Nebraska Public Power District

NLS2017095
November 30, 2017

Subject: Response to Nuclear Regulatory Commission Request for Additional Information
for Relief Request RI-21, Revision 1
Cooper Nuclear Station, Docket No. 50-298, DPR-46

**Response to Nuclear Regulatory Commission Request for Additional Information
for Relief Request RI-21, Revision 1**

Figure 1

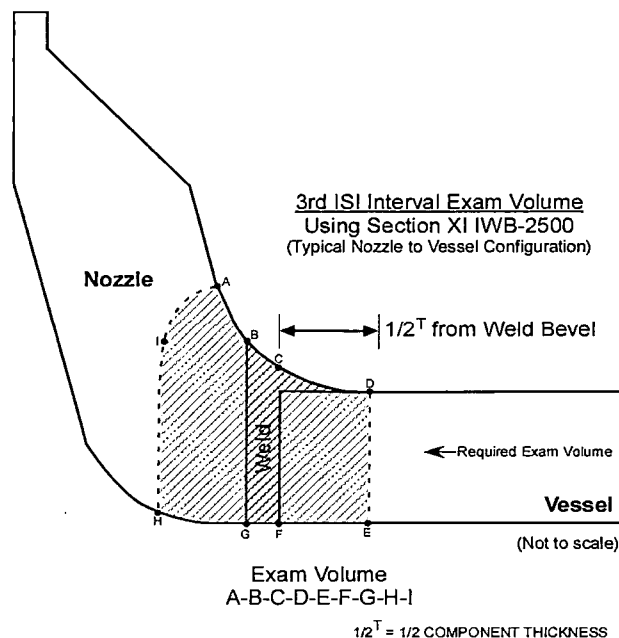
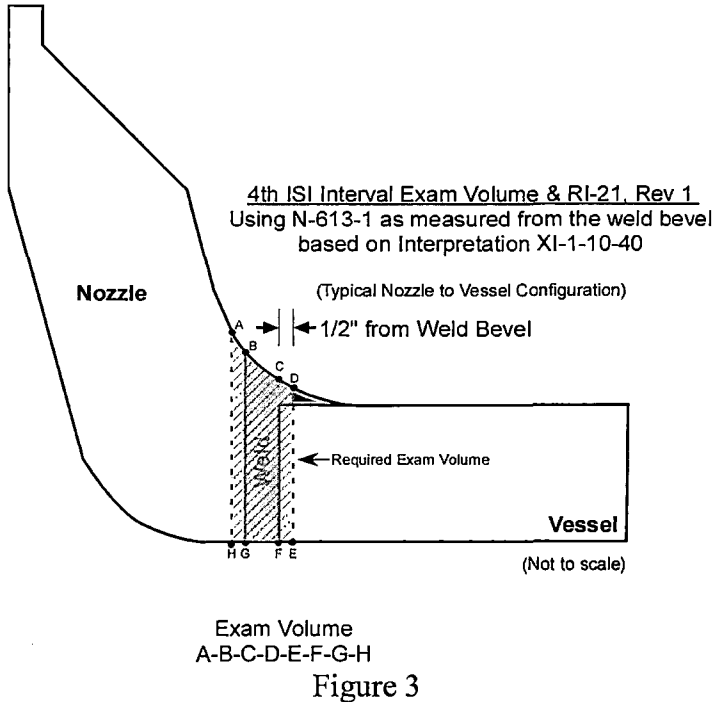
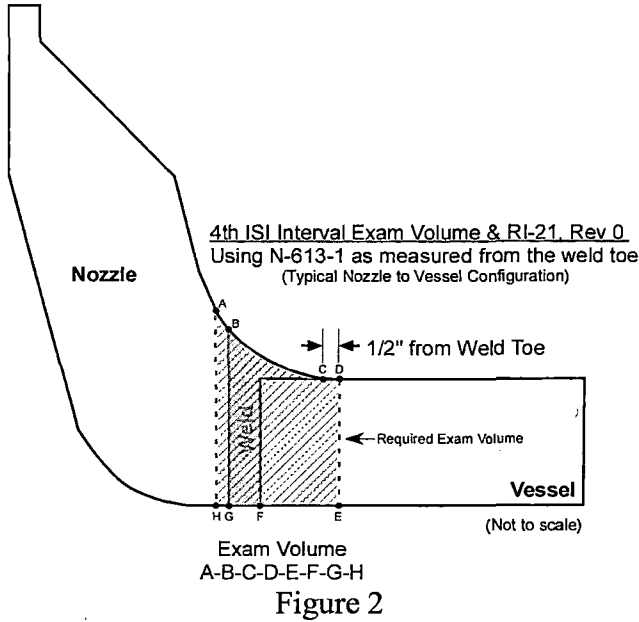
For several of the RPV nozzle welds addressed in RI-21, Rev. 1, the licensee reported limited scope examination coverages that had decreased from those that were previously approved by the NRC for an earlier version of this fourth ISI interval relief request. Specifically, in its safety evaluation dated January 12, 2010 (ADAMS Accession No. ML093521350), for Relief Request No. RI-21, Rev. 0, dated February 16, 2009 (ADAMS Accession No. ML090540420), the NRC staff granted relief for limited-scope examinations for several of the RPV nozzle welds that are now addressed again in RI-21, Rev. 1, with lower reported coverages. The limited scope exams that were previously approved for the fourth ISI interval are identified in Table 1 below.

a. For those RPV nozzle weld exam limitations that were previously approved per RI-21, Rev. 0, please state whether the actual UT that achieved the limited coverages reported in RI-21, Rev. 1 are the same as those previously addressed in RI-21, Rev. 0. Specifically, were the new reduced examination coverages addressed in RI-21, Rev. 1 determined exclusively by recalculation?

b. If the changes to the RPV nozzle weld limited coverages from RI-21, Rev. 0 to RI-21, Rev. 1 were determined exclusively by recalculation, please explain whether the recalculated limited examination coverages for RI-21, Rev.1 were based on:

- c. The NRC staff identified that relief was not previously requested or approved in RI-21, Rev. 0 for the reactor feedwater nozzles, top head spray nozzle, top head vent nozzle, CRD return line nozzle, and several of the recirculation inlet nozzles. For these nozzle weld exams, please explain how the application of Code Case N-613-1 for the fourth ISI interval would result in lower exam coverages than those reported for the third ISI interval, given that the full scope (100 percent) exam volume per the Code Case is lower than that required by Figure IWB-2500-7 of the Code. The response to this part should also address any other reasons for a reduction in examination coverage from third to fourth ISI interval not related to Code Case N-613-1 (e.g., such as corrective action for crediting excessive exam coverage, similar to issues raised in RAI-5).*

- d. For the top head vent nozzle, there are inconsistencies in the discussion of the third ISI interval examination coverages in Section 8.0 of Appendix 1 of the attachment to RI-21, Rev. 1. Specifically, the table in this section specifies a third ISI interval examination coverage of "58.6" percent in 1998, whereas the "Note 1" text beneath the table states that previous exams from 1995 and 2001 reported a coverage of "92.25" percent. Please clearly state the actual third ISI interval examination coverage and the corresponding calendar year when this exam was performed.*

- b. Due to questions regarding the definition of the full scope (100 percent) volume specified in Figure IWB-2500-7(a) as well as the alternative reduced examination specified in Figure 1 of ASME Code Case N-613-1, CNS requested ASME Section XI clarify the examination volume requirements for the CNS nozzles since the nozzle-to-shell blend radius weld extended well beyond the weld bevel. ASME responded with Interpretation XI-1-10-40 that clarified the examination volume in ASME Section XI and Code Case Figures, i.e., A-B-C-D-E-F-G-H-I in Figure IWB-2500-7(a) and A-B-C-D-E-F-G-H in Figure 1, respectively, is determined from the weld bevel vs. the toe of the nozzle-to-shell blend radius weld as previously calculated. It should also be noted that there was a typographical error in RI-21, Revision 1, where Note 1 for nozzles N1A (page 12), N2 (page 18), N3 (page 23), and N5 (page 40) made reference to 1/2T which should have been 1/2 inch.

Changes in the way CNS applied the definition of the alternative reduced volume in N-613-1 is the basis for the changes in coverages from RI-21, Revision 0, to RI-21, Revision 1. Additional nozzles that were added with Revision 1 because they were examined later in the

Interval were calculated from the alternative reduced volume based on the clarification of the ASME Interpretation. Figures 1, 2, and 3 identify how the examination volume was applied to the CNS nozzles. Figure 1 identifies how the volume was defined in the Third Interval (T/2 beyond weld bevel, nozzle and vessel sides). Figure 2 identifies how the volume was defined for the nozzles listed in RI-21, Rev. 0 (1/2 inch beyond the weld toe of the blend-radius on the vessel side, 1/2 inch beyond the bevel on the nozzle side). Figure 3 identifies how the examination volume was defined for all the nozzles examined in the Fourth Interval (1/2 inch beyond weld bevel, both sides) after clarification per Interpretation XI-1-10-40. The reduction of the vessel side exam volume from 1/2 inch beyond the weld toe of the blend-radius on the vessel side (Revision 0, Figure 2) to 1/2 inch from the weld bevel (Revision 1, Figure 3) attributed to an 18 to 22 percent loss in total reported coverage on the applicable welds previously stated in RI-21, Revision 0. The methodology used for determining and crediting the examination coverages was not changed between the two versions of the Relief Request.

- c. The differences between the Third and Fourth Interval coverages are due to the change in the way CNS defined the examination volume in the Third Interval (Figure 1) compared to the Fourth Interval (Figure 3). Figure 1 shows the Third Interval examination volume vs. Figure 3 that shows the Fourth Interval examination volume associated with the reactor feedwater nozzles, top head spray nozzle, CRD return nozzle, and several recirculation inlet nozzles. The top head vent nozzle is a slightly different configuration that resulted in a slight increase of coverage from the Third to Fourth Interval (i.e., 58.6% to 59.09%).
- d. The first sentence in Note 1 was a "copy and paste" error carried over from the RHR-CA-2A note section and therefore is not applicable to NVE-BD-N7. The achieved examination coverage for this weld in the Third Interval was 58.6% in RE18 (1998).
